Project # 24026 – SJCPL Centre Branch Renovations
1150 Kern Rd, South Bend, IN 46614

ADDENDUM No. 3

October 21, 2024

E-301

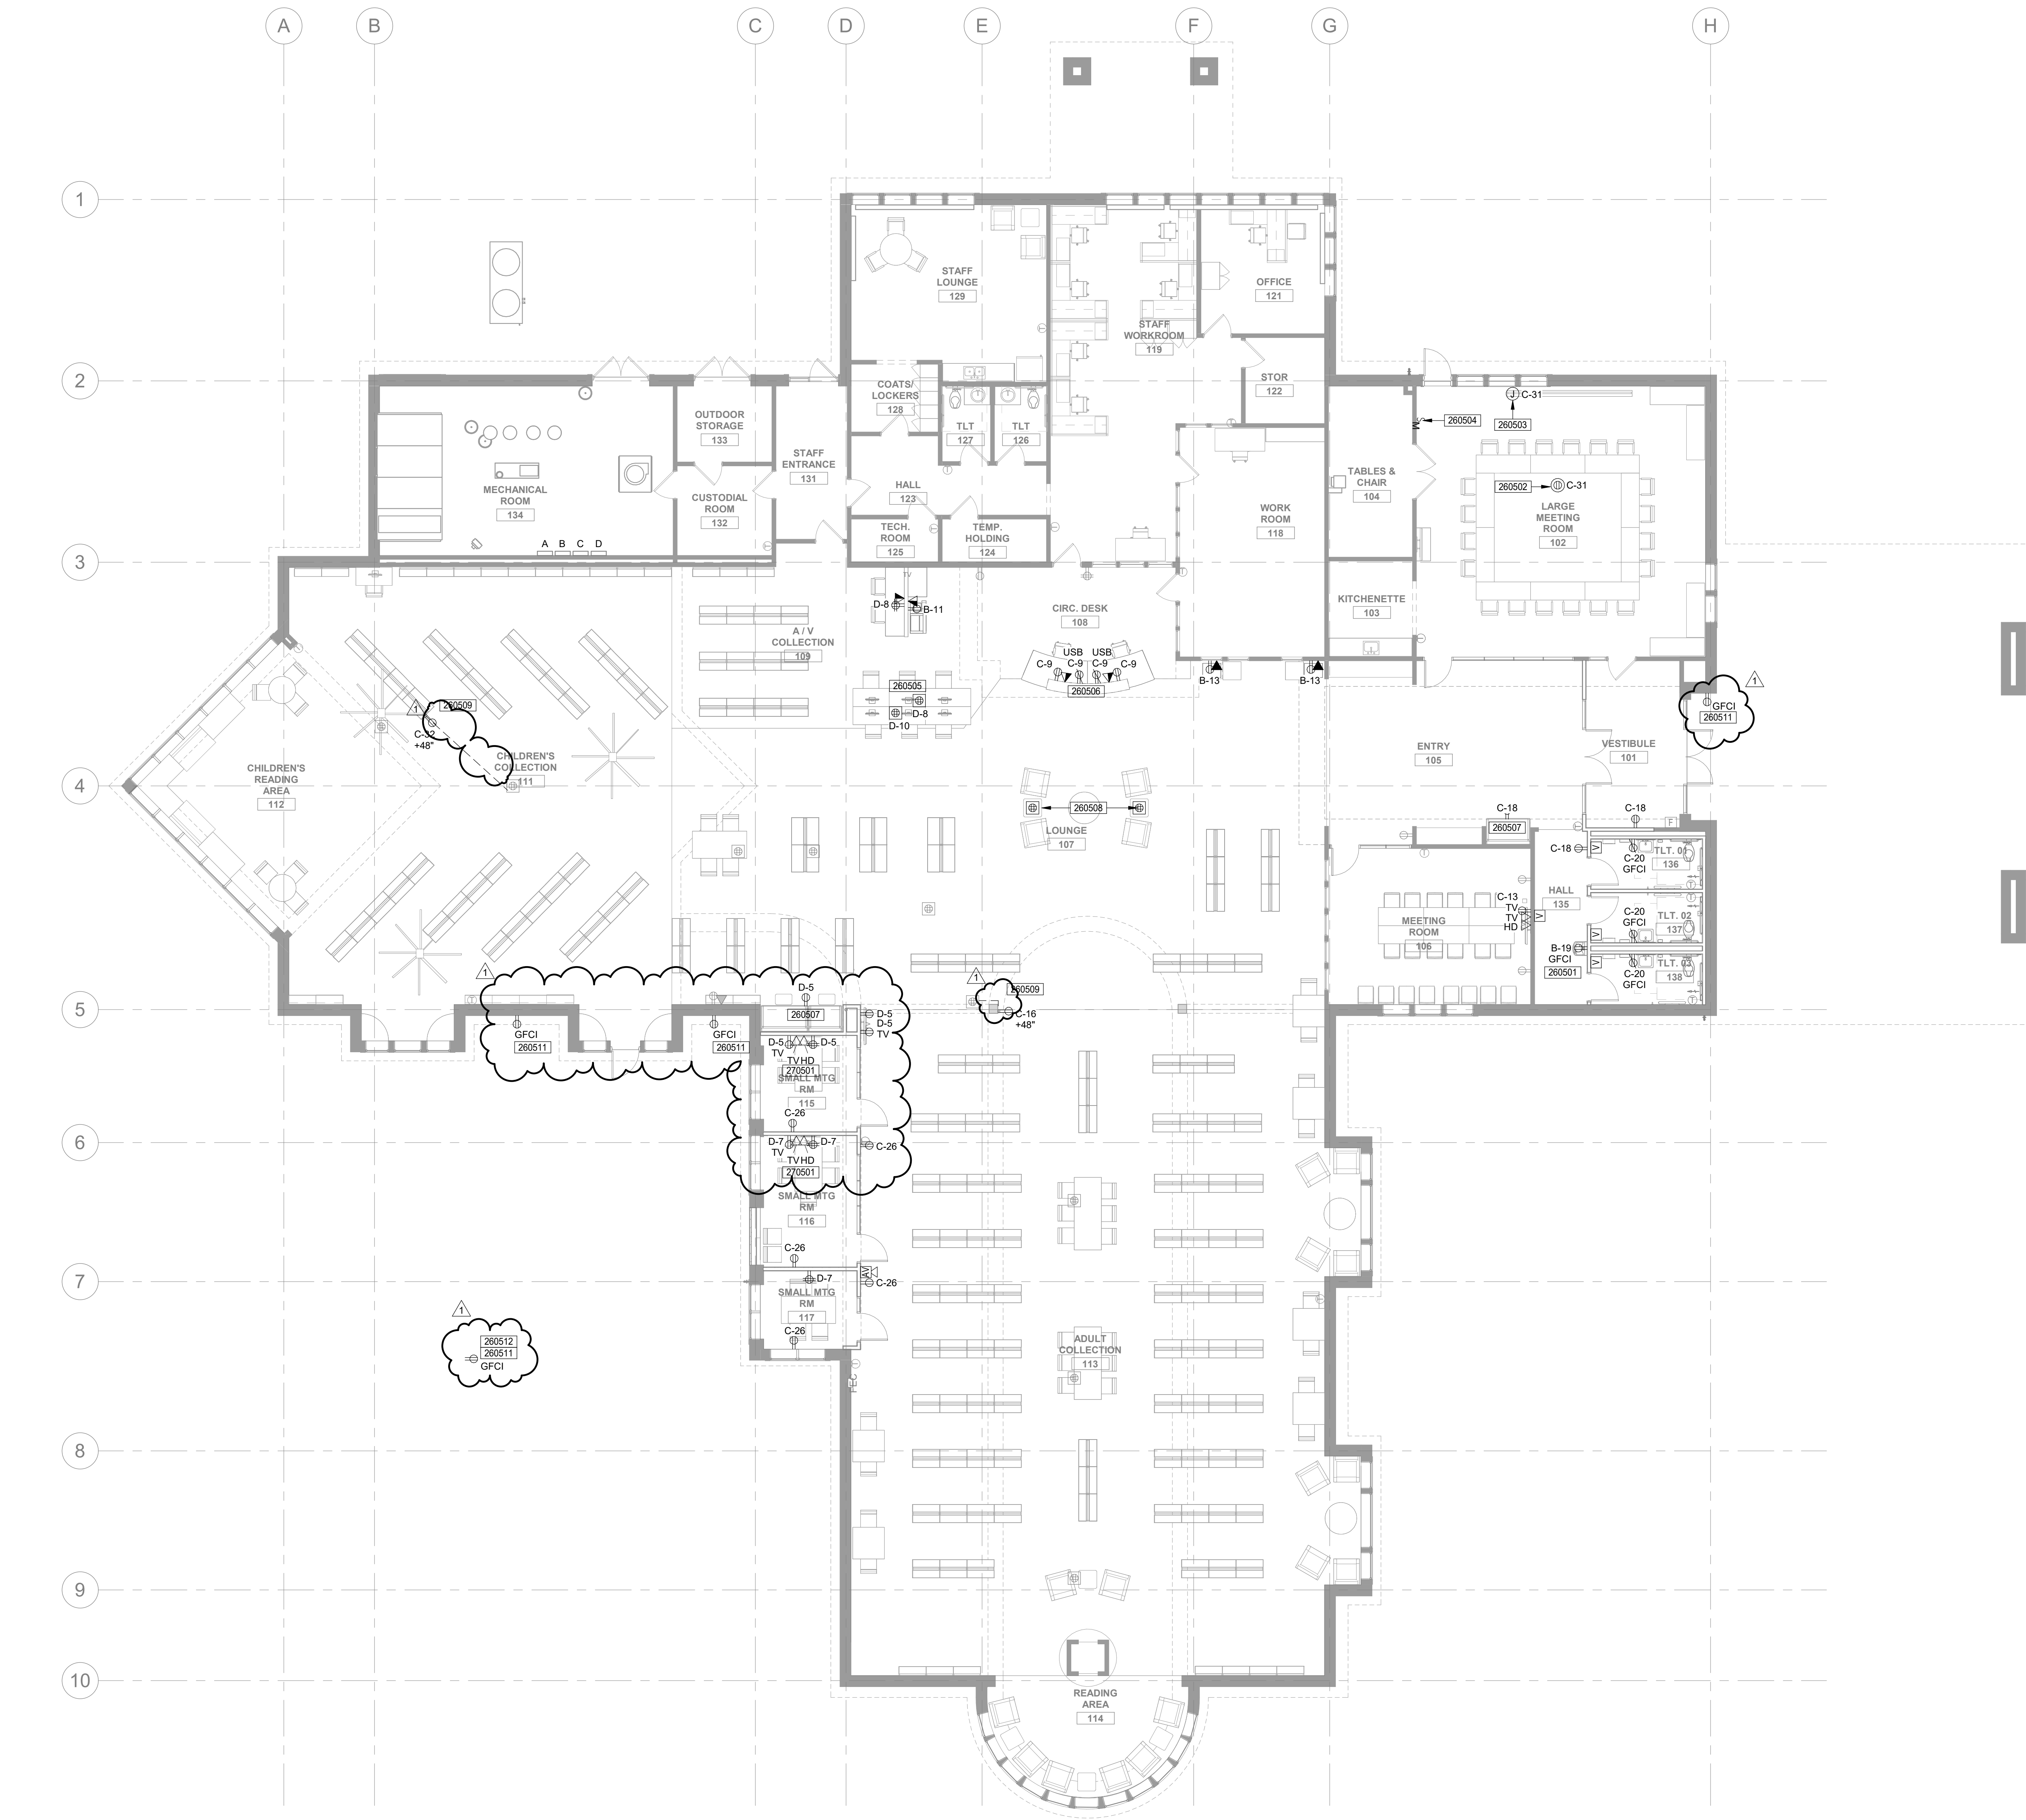
14. Sheet E-301 – Lighting Installation Plan

- (a) **Clarification:** See updated plan with battery backup lights indicated with half-shaded fixture symbols.
